CHAPTER 9.0 LETTERS OF COMMENT AND RESPONSES

This chapter contains all comments received on the Draft Environmental Impact Report (DEIR) and responses thereto and is organized as follows:

Graph 1 - Common Spectral Surfaces

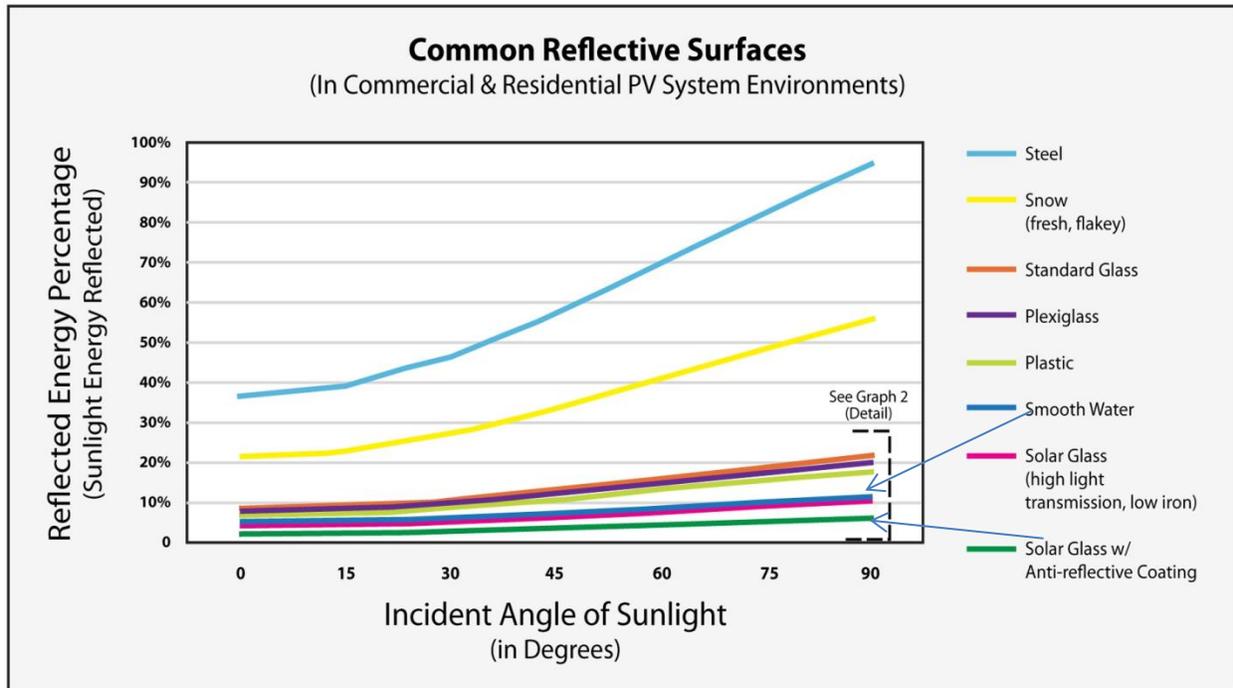
BIO1- Pseudo-Lake Effect. As described in DEIR page 2.2-34, the Proposed Project area is located within the Pacific Flyway for migratory avian species; however, the Proposed Project site is located east of the main coastal migration route and west of the primary route between the Gulf of California and the Salton Sea. The potential effects of the pseudo-lake effect are discussed on pages 2.2-46 and 2.2-47 of the DEIR. The analysis acknowledges anecdotal evidence of wetland species colliding with or becoming stranded in solar fields, that some have hypothesized is possibly because birds might be attracted to the solar arrays if the solar arrays mimic water bodies. Little is known about whether avian species and individuals that are negatively affected by glare or the hypothesized pseudo-lake effect of PV arrays. The USFWS recognizes the lack of data on the effects of solar facilities on migratory bird mortality and has provided guidance on monitoring migratory bird mortalities at solar facilities (Nicolai et al. 2011). The April 2015 National Renewable Energy Laboratory (NREL) report on Avian

Accordingly, the experts that prepared the DEIR reviewed the available literature and found no credible evidence that the Project creates a significant pseudo lake effect threat to avians and therefore CEQA does not require alterations to the Project’s location or design to mitigate an impact that is not significant or too speculative for evaluation. CEQA Guidelines 15126.4(a)(3) states, “[m]itigation measures are not required for effects which are not found to be significant.” The CEQA Guidelines further specify that “if, after thorough investigation, a lead agency finds that a particular impact is too speculative for evaluation, the agency should note its conclusion and terminate discussion of the impact.” (CEQA Guidelines, §15145.) When determining whether an EIR complies with applicable legal requirements, courts may not interpret CEQA or the CEQA Guidelines in a manner that would impose procedural or substantive requirements beyond those explicitly stated in the statute or the Guidelines. Pub. Res. Code §21083.1; *California Oak Found. v Regents of Univ. of Cal.* (2010) 188 Cal App 4th 227, 265; *Western Placer Citizens for an Agric. & Rural Env’t v County of Placer* (2006) 144 Cal App 4th 890, 899; *Martin v City & County of San Francisco* (2005) 135 Cal App 4th 392, 402; *Dry Creek Citizens Coalition v County of Tulare* (1999) 70 Cal App 4th 20, 36; *Los Angeles Unified Sch. Dist. v City of Los Angeles* (1997) 58 Cal App 4th 1019, 1029; *Chaparral Greens v City of Chula Vista* (1996) 50 Cal App 4th 1134, 1145. Therefore, because there is no CEQA requirement to impose mitigation to reduce a speculative impact to avian species, it is within the County’s discretion to simply require the applicant to monitor and record any avian mortalities without further analysis of whether that requirement is effective in mitigating any speculative impact to below a level of significance. CEQA Guidelines, §15145 simply informs the agency to “terminate the analysis.” To clarify, for the sake of convenience and tracking project requirements, the County has placed this avian monitoring and reporting requirement in the MMRP, but does not rely on it for mitigation because there is no finding of a significant impact to avian species from the pseudo-lake effect. To the extent there will be any avian mortalities at the project site, the County and the applicant will contribute to the data that can assist future decision makers in determining the cause of an avian mortality and setting a policy that is not based on speculation.

Furthermore, the Proposed Project is backed up between a mountain and a large existing fence (International Border Fence). The Proposed Project would have solar units that are uniformly dark in color, coated to be non-reflective, and designed to be highly absorptive of all light that strikes their glass surfaces so they would not appear like water from above, as water displays

different properties by both reflecting and absorbing light waves. (See DEIR, p. 2.2-47.) The Proposed Project’s panels are approximately 12.5 feet apart, which breaks up sky reflection from a single continuous surface to individual separate units and reduces the image of a continuous body of water. The charts included below demonstrate the low reflectivity of PV panels with anti-reflective coatings like the ones for this Project compared to other surfaces, including water (Common Reflective Surfaces Source: SUNPOWER 2010, PV Systems: Low Levels of Glare and Reflectance vs. Surrounding Environment).
